RE: 1105 Front Street NE – The Cannery (Reference No. 24-106451-PLN) Completeness Response

Reference Nos.: 24-106451-PLN (Class 3 Site Plan Review, Tentative Subdivision Plan, Class 1 & 2 Adjustment, Class 2 Driveway Approach Permit)

PRELIMINARY SITE PLAN
THE CANNERY
FUND
SALEM, OREGON

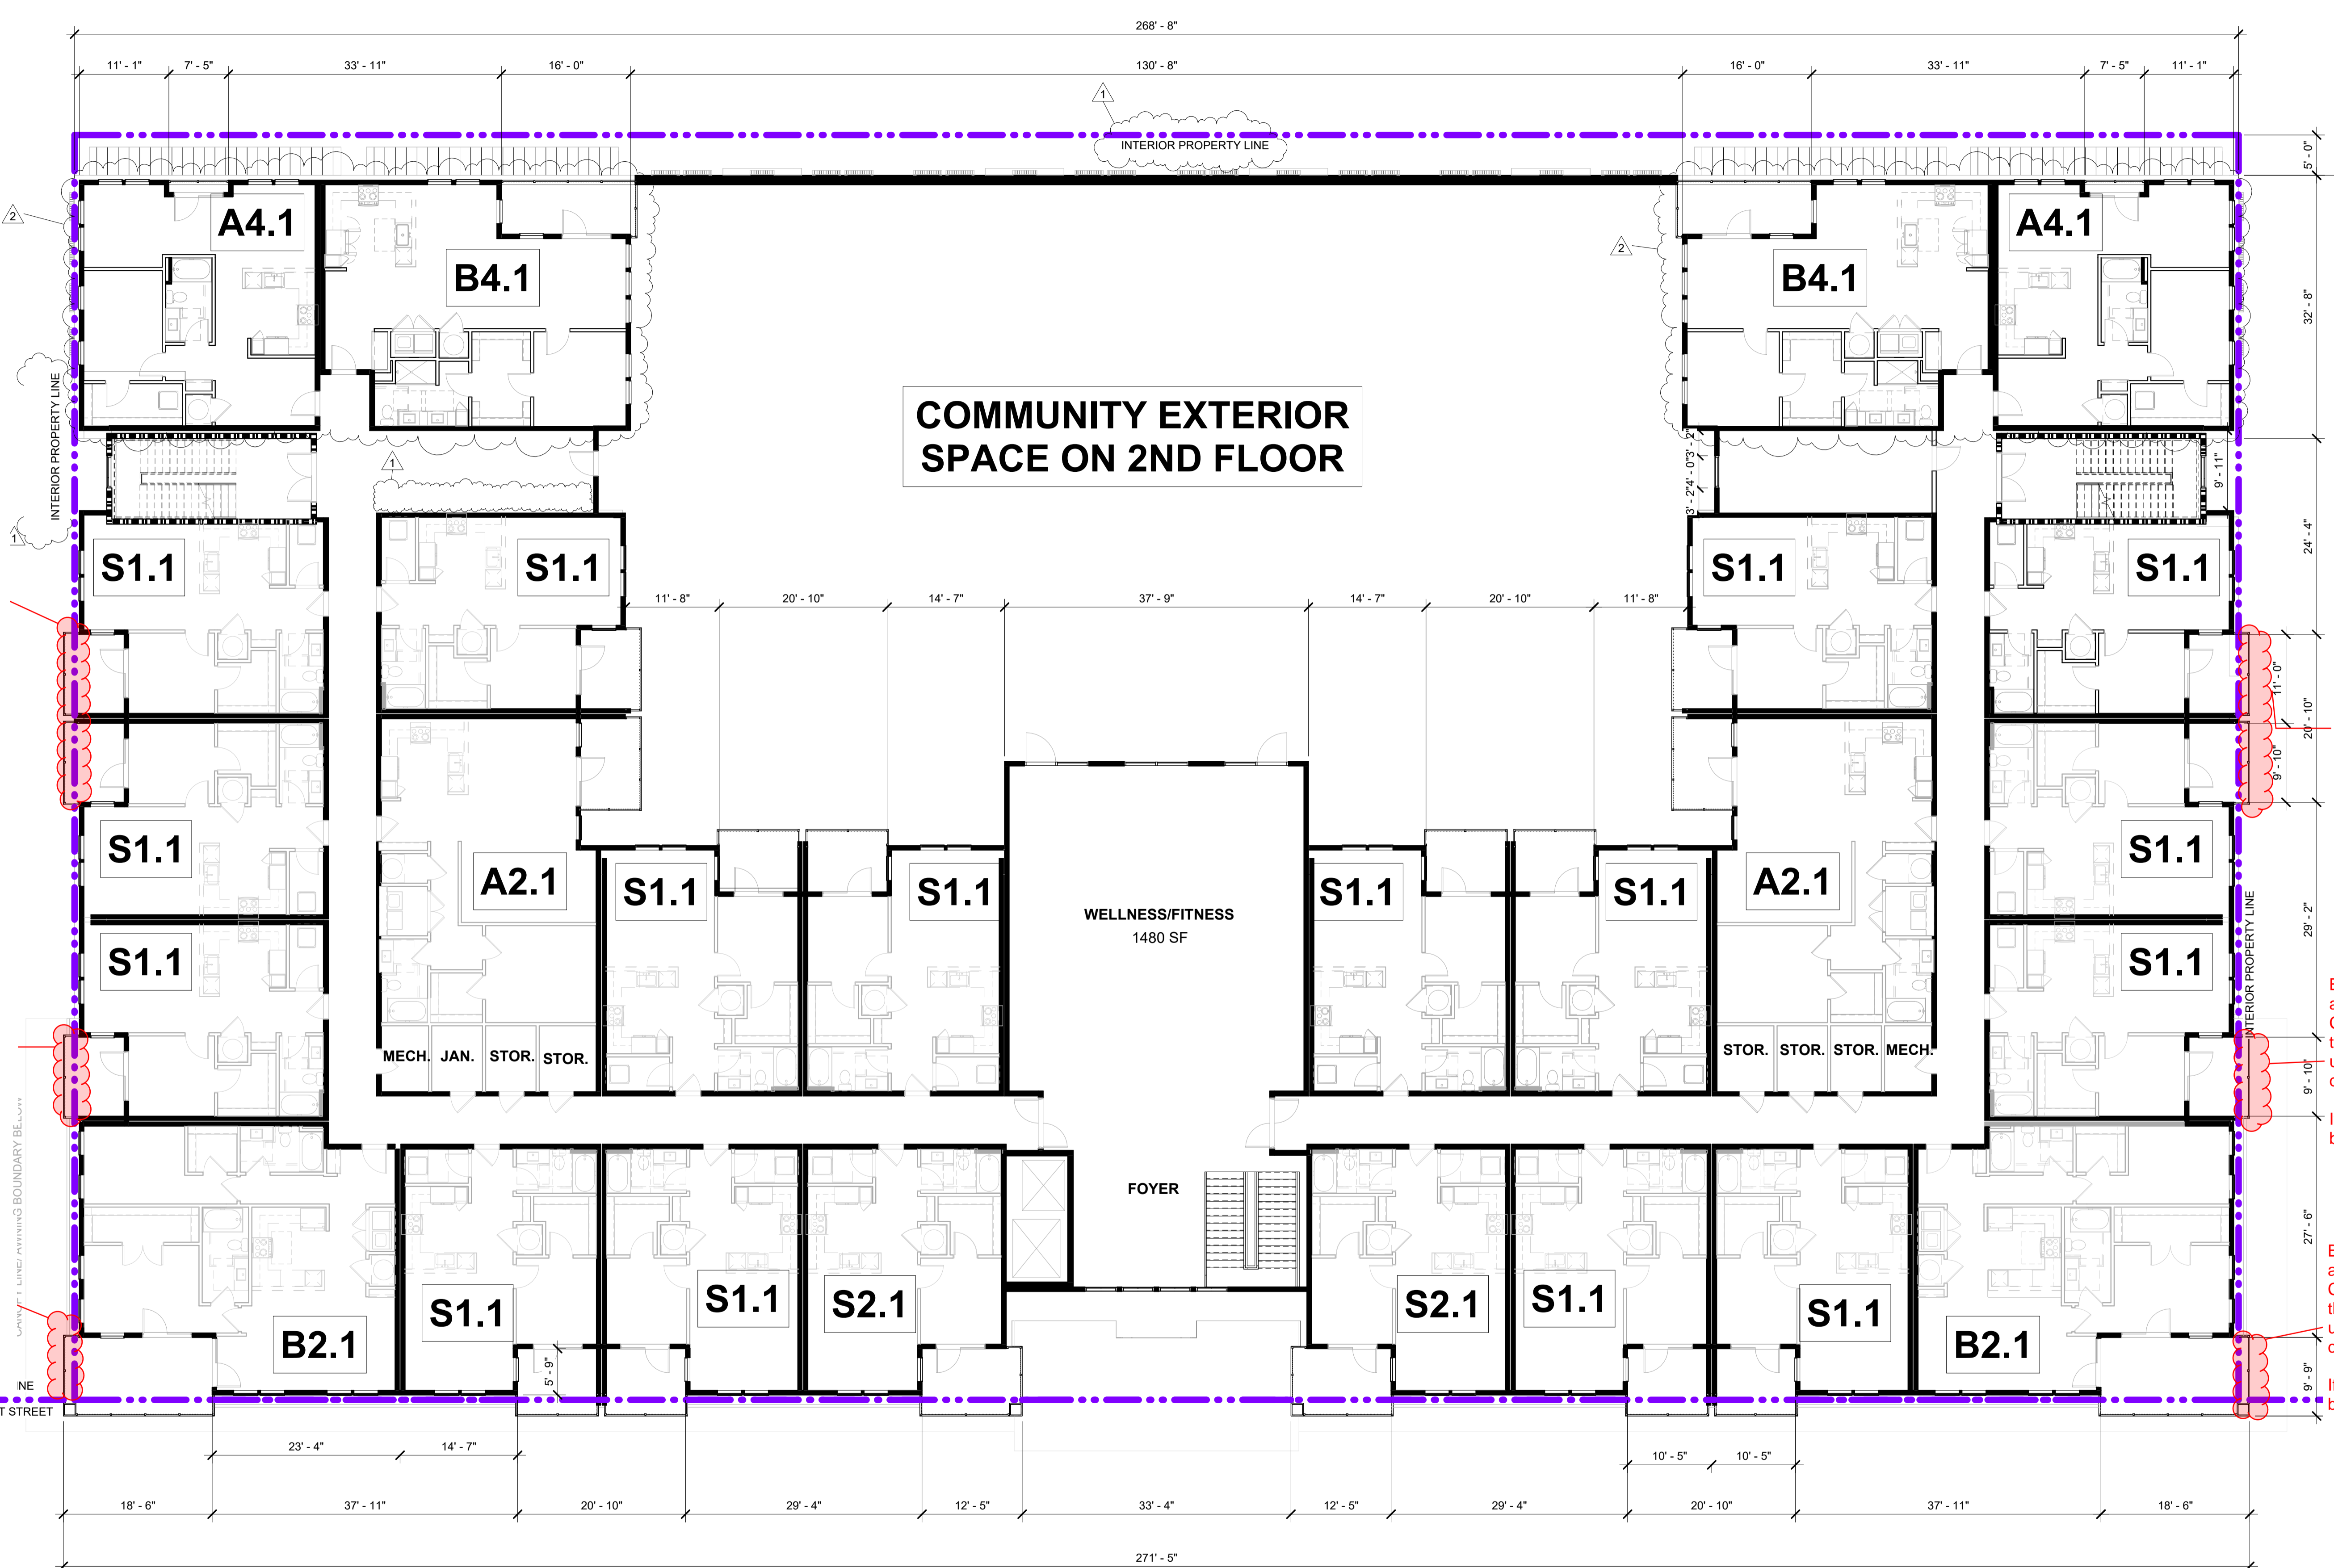
Balconies project across property line. Confirmation required if this will be allowed under the building code.
If so, an easement will be required.

Response: Planned property lines have been modified such that no canopies, balconies, or living space project across a property line as detailed on the revised Preliminary Building Elevations and Floor Plans in Attachment E. The 6th floor living space that projected into the Front Street NE right-of-way has been modified. This item is met.

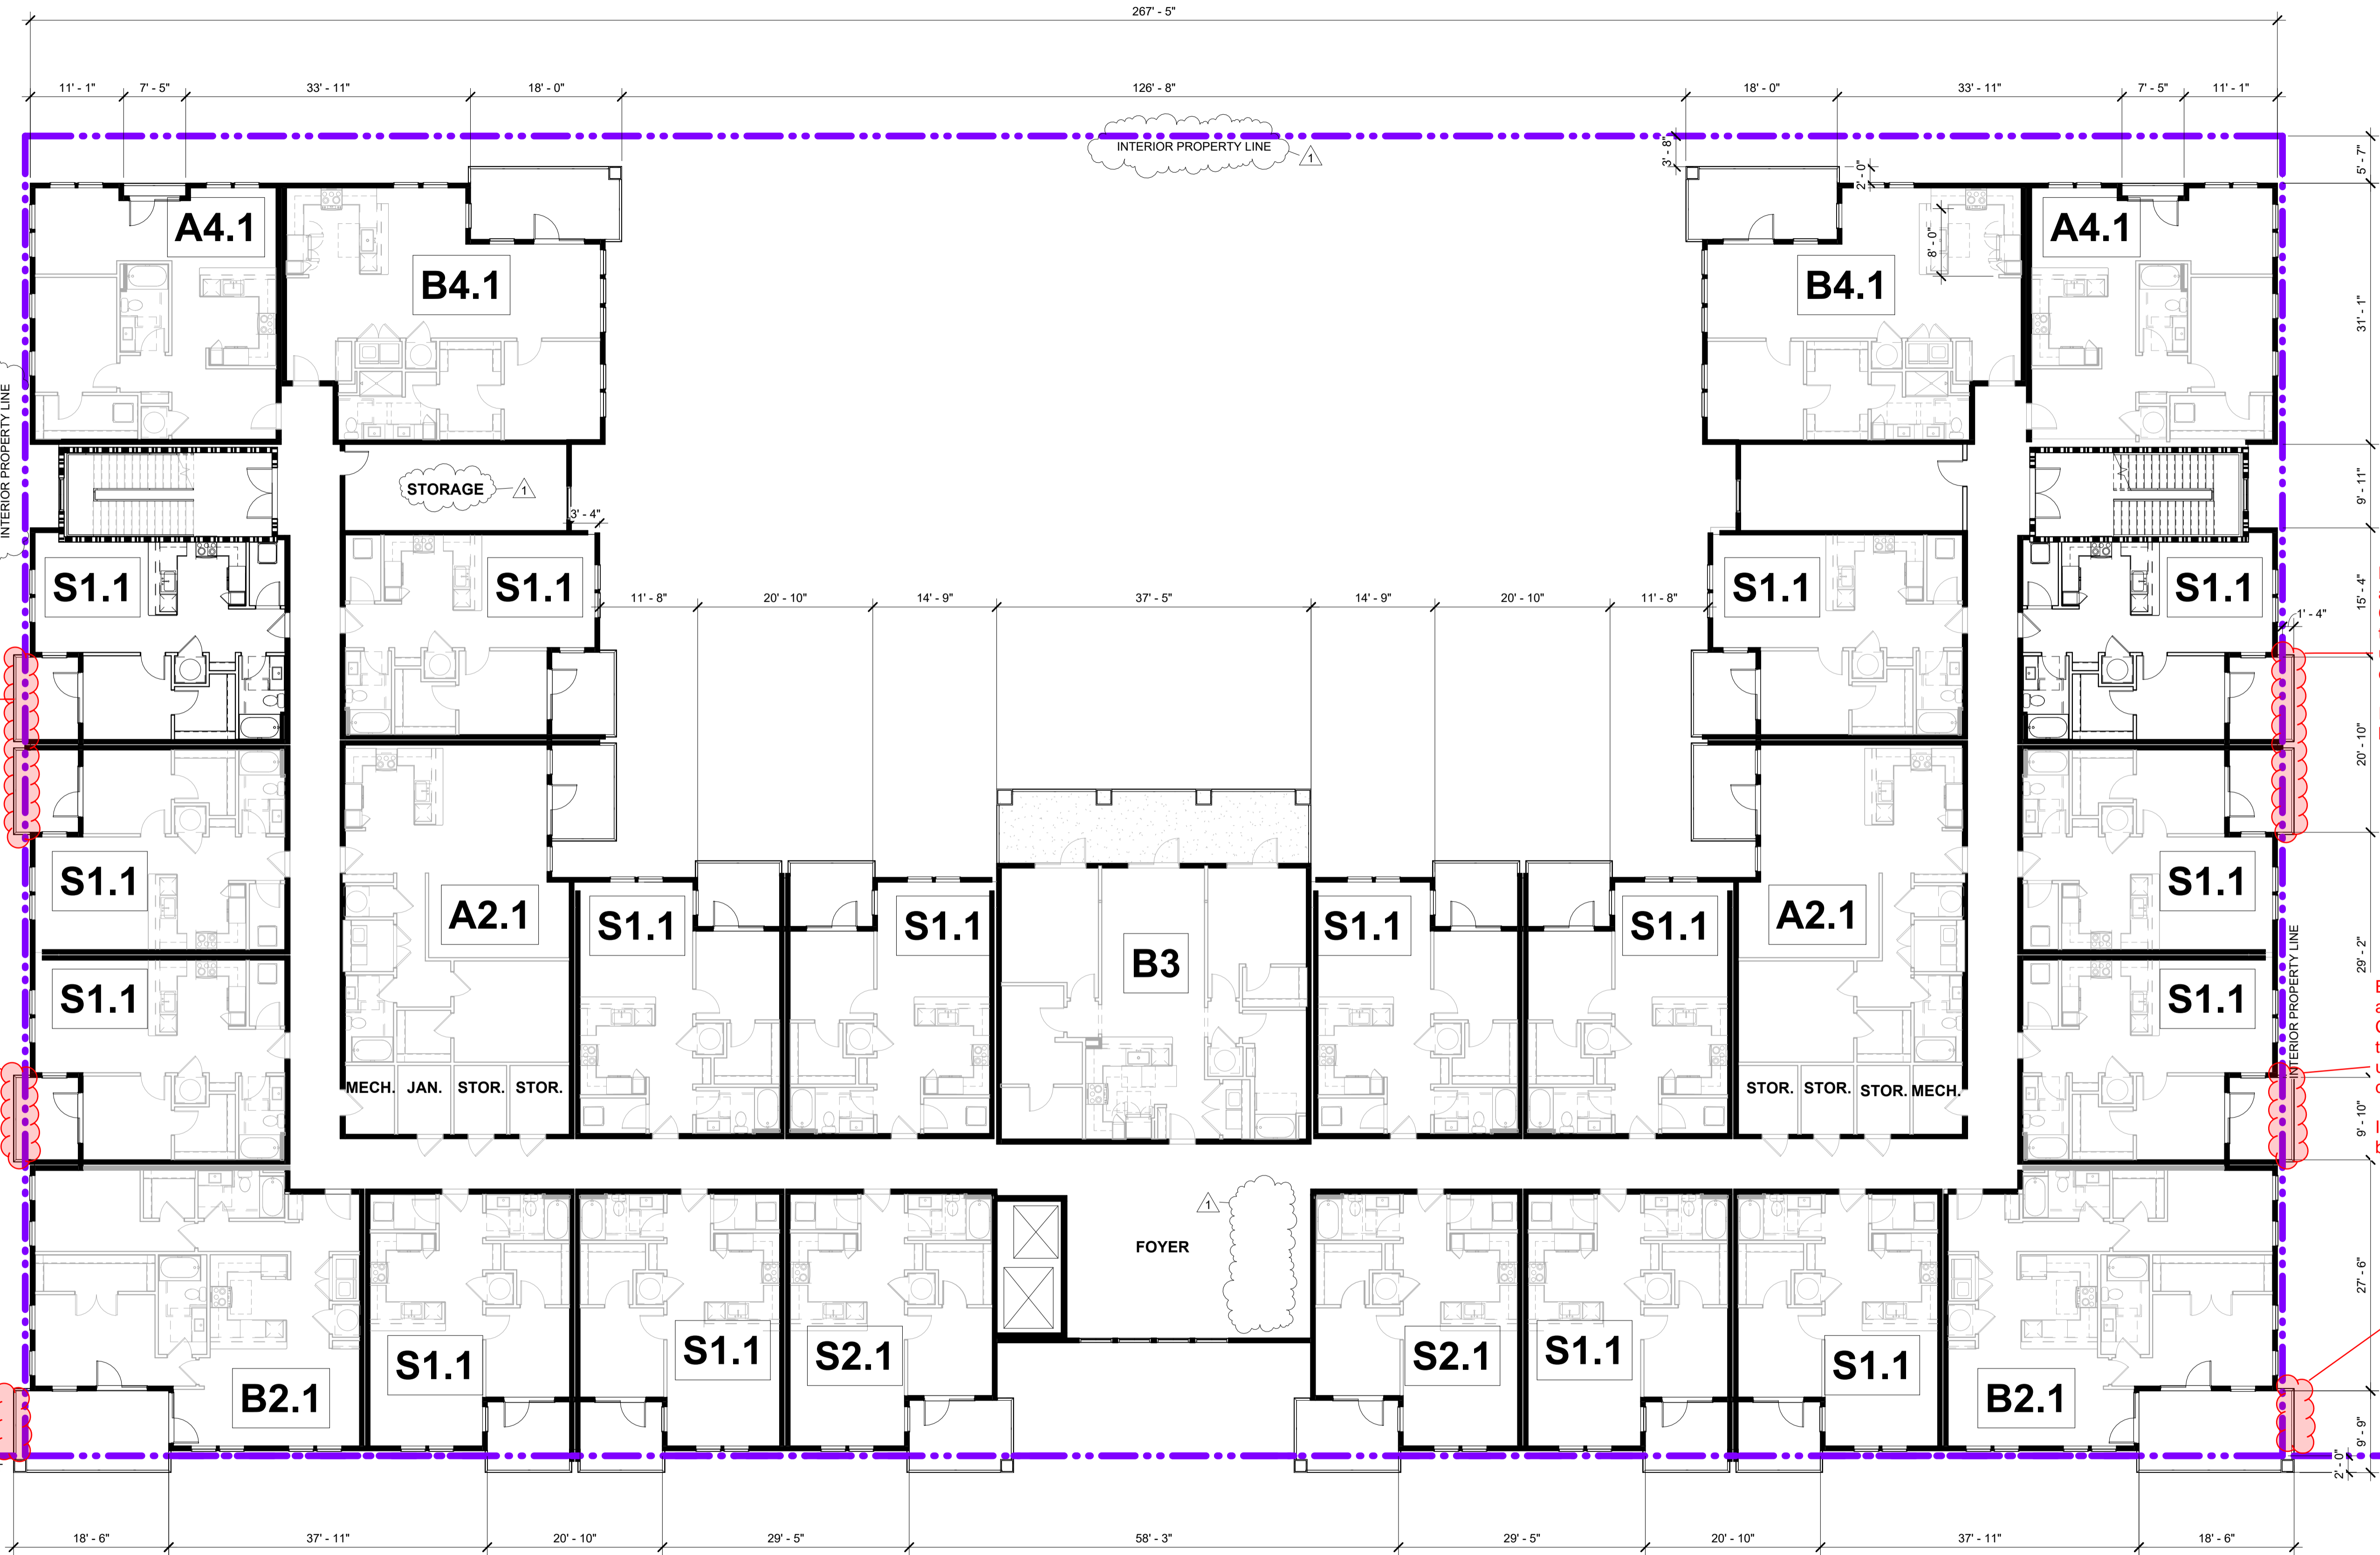
Balconies project across property line. Confirmation required if this will be allowed under the building code.
If so, an easement will be required.

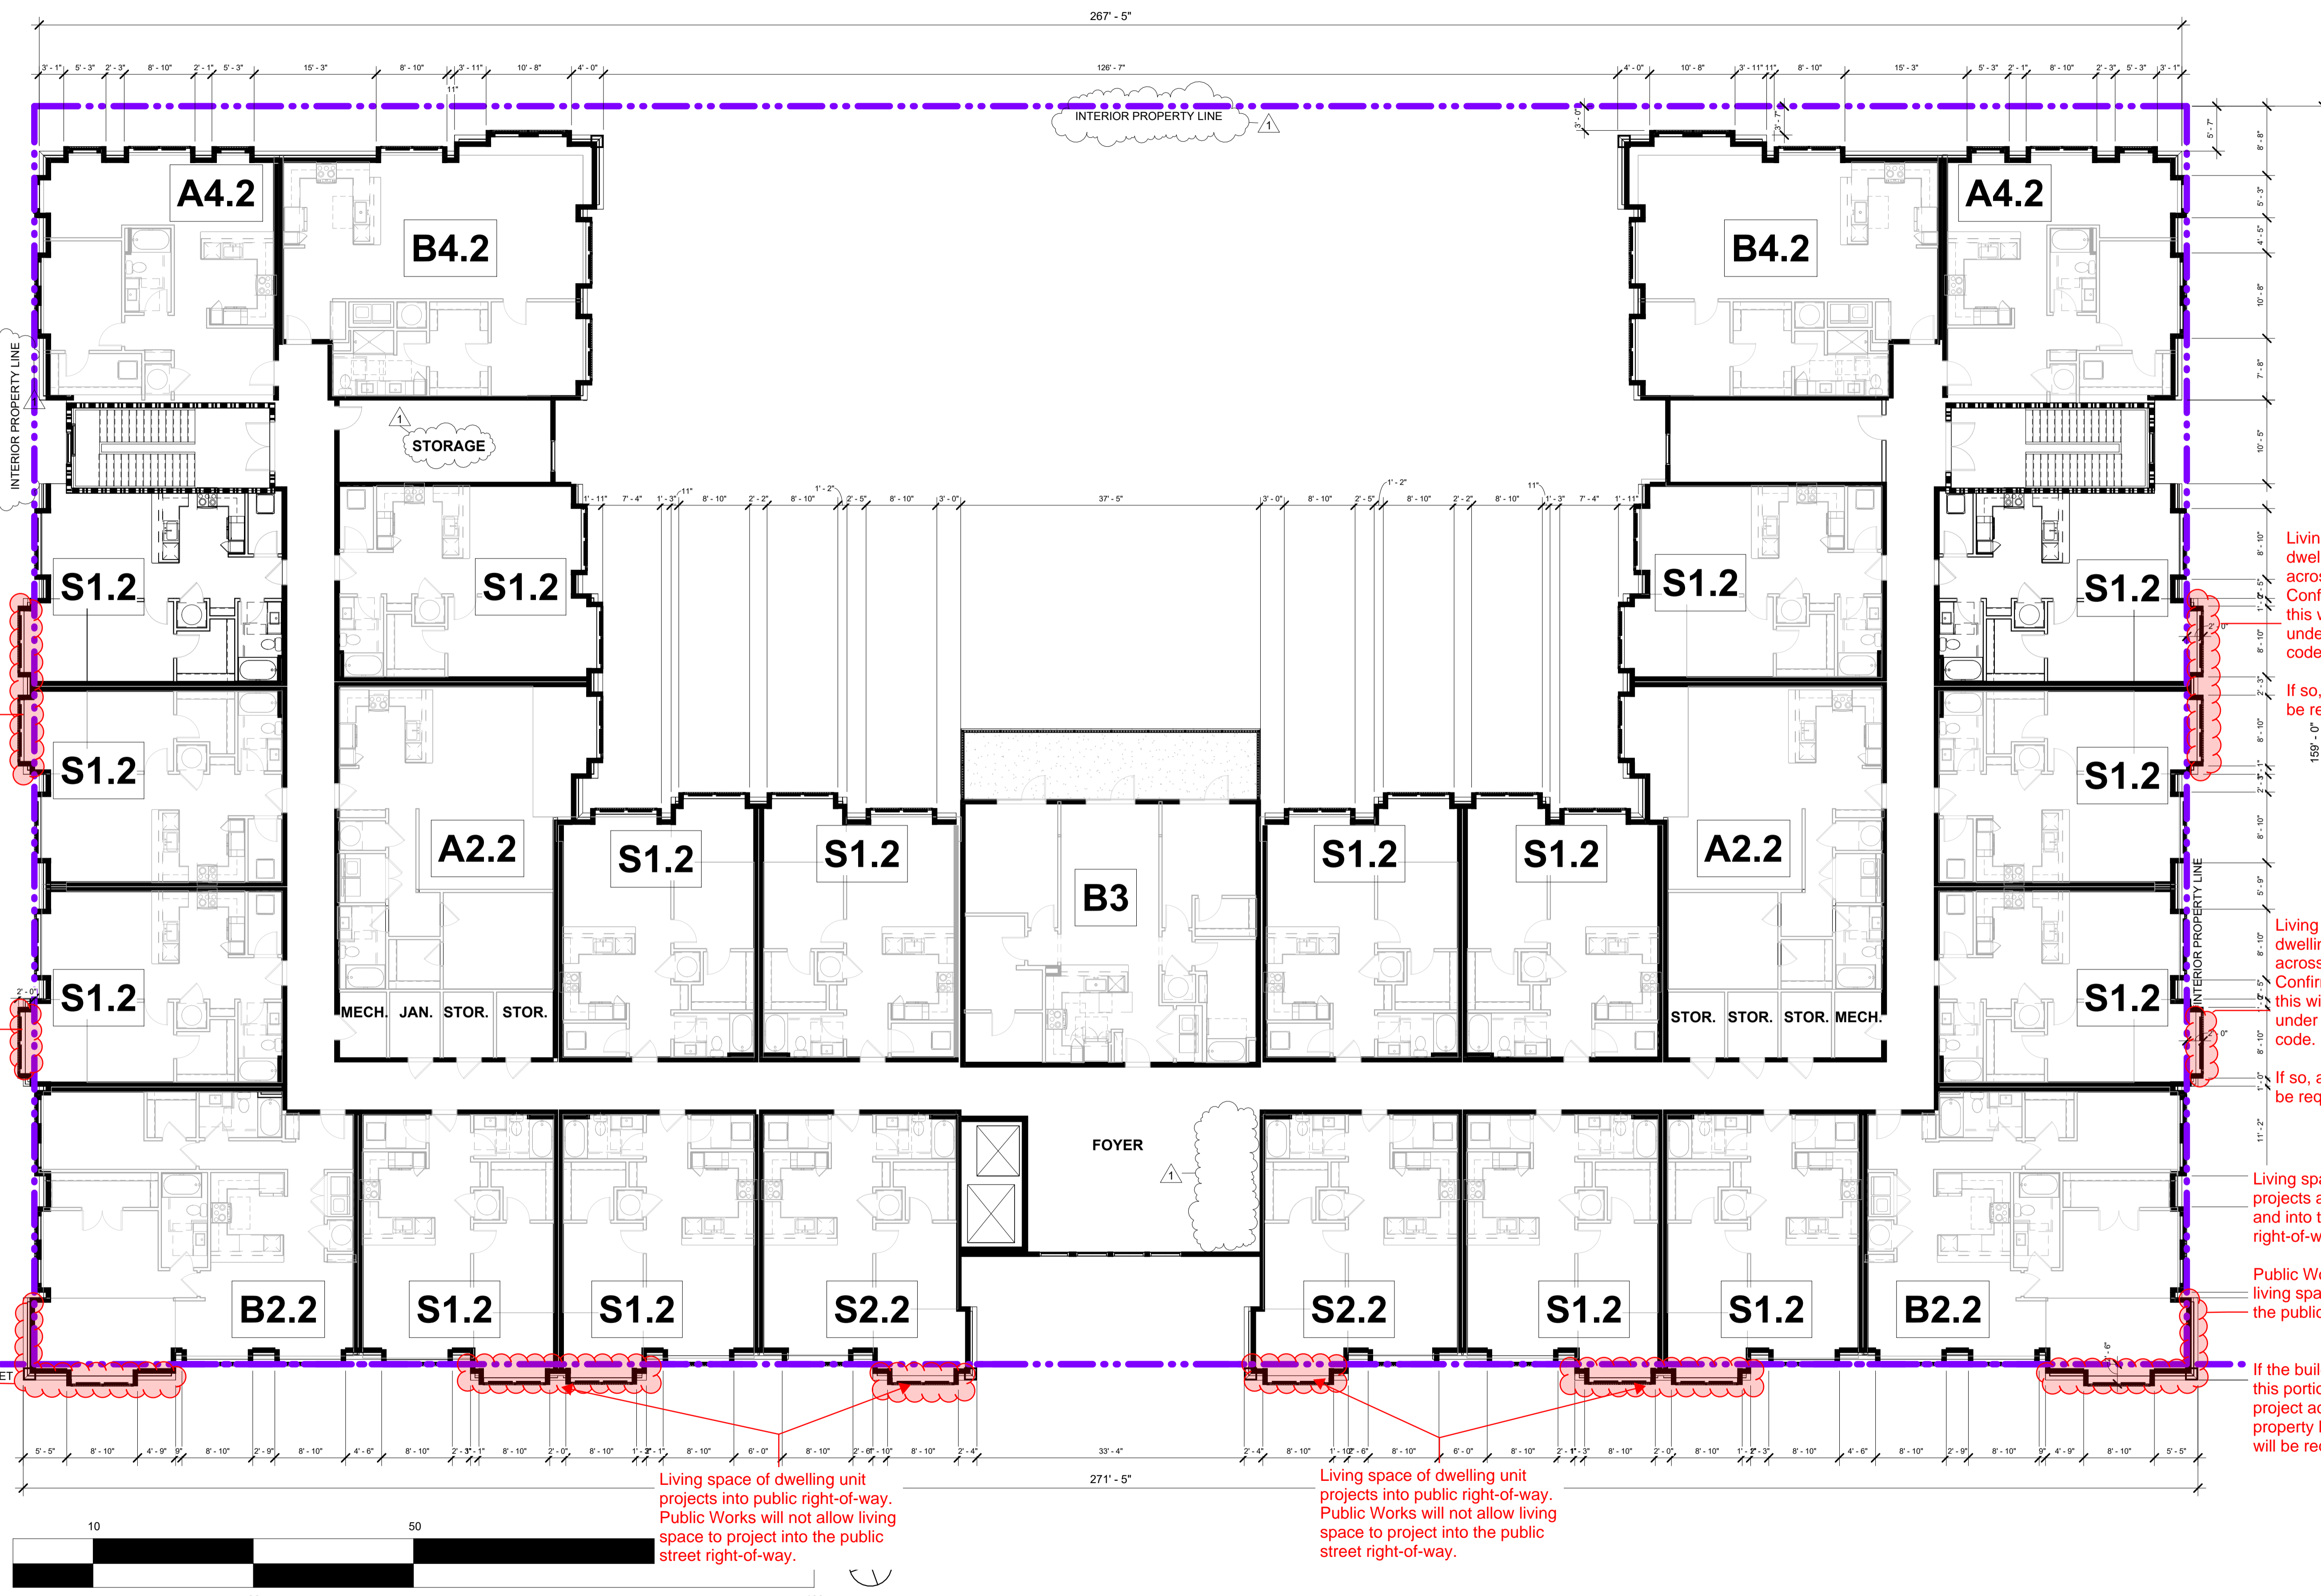
Living space of dwelling units project across property line. Confirmation required if this will be allowed under the building code.

If so, an easement will be required.
